**June 24, 2022**

Version 1

## Civic Coupe Trunk Spring Replacement

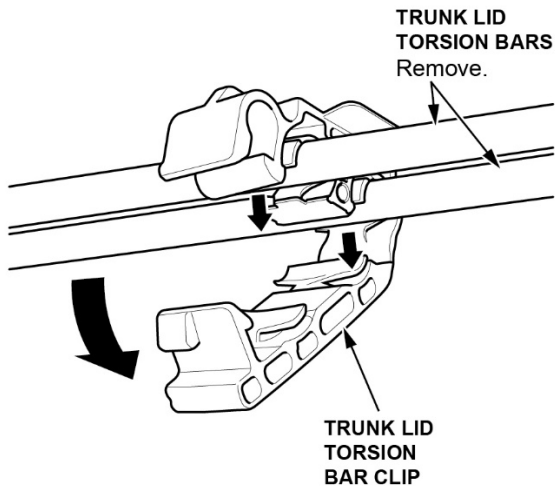
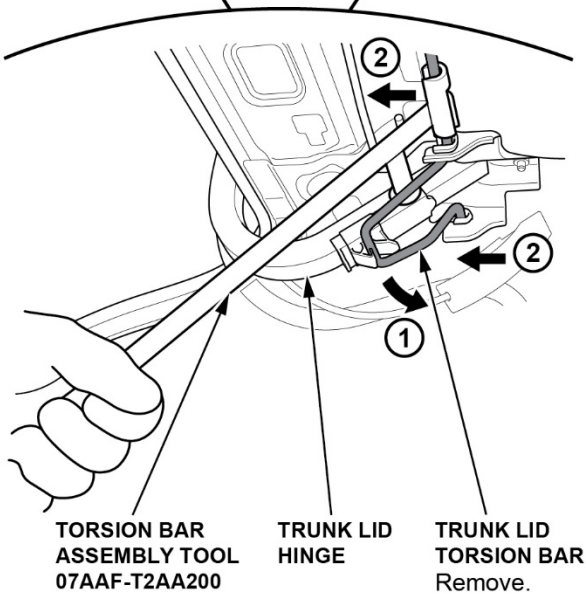
2. Remove the trunk lid torsion bars from the trunk lid torsion bar clip.

NOTE: Take notice of the clip orientation upon disassembly as it will be turned **180 degrees** in the opposite direction upon reassembly.

5. Remove the clip and rotate it 180 degrees.

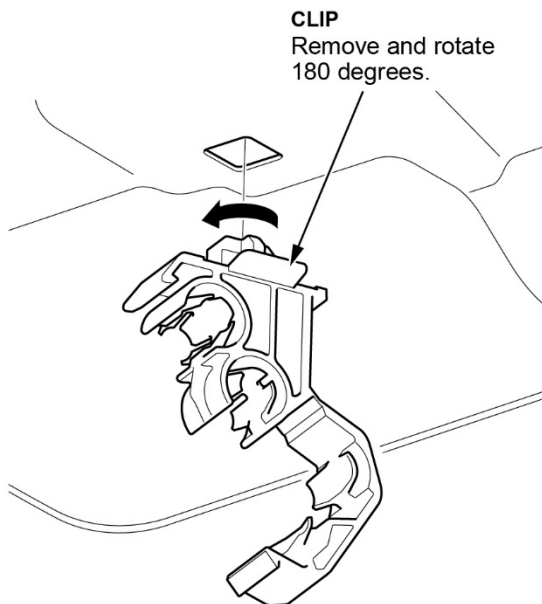
4. If necessary, remove the trunk lid torsion bar holders and the trunk lid torsion bar slider.
